JLS CONVERSION TO IMPROVED TECHNICAL SPECIFICATIONS

CTS 3.4 - REACTOR COOLANT SYSTEM

ITS 3.4 - REACTOR COOLANT SYSTEM

RESPONSE TO REQUEST FOR ADDITIONAL INFORMATION AND LICENSEE INITIATED ADDITIONAL CHANGES

REQUEST: ITS Figure 3.4.16.1 (Wolf Creek)

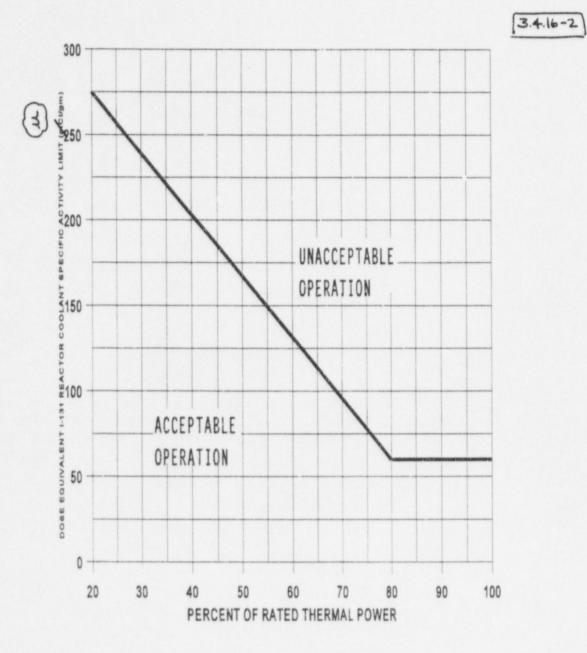
**Comment**: In order to be consistent with the ITS LCO and CTS Figure 3.4-1 the units should be micro ( $\mu$ ) Curies/gm and not milli (m) Curies/gm as indicated.

FLOG RESPONSE: ITS Figure 3.4.16-1 units have been revised to "(µCi/gm)".
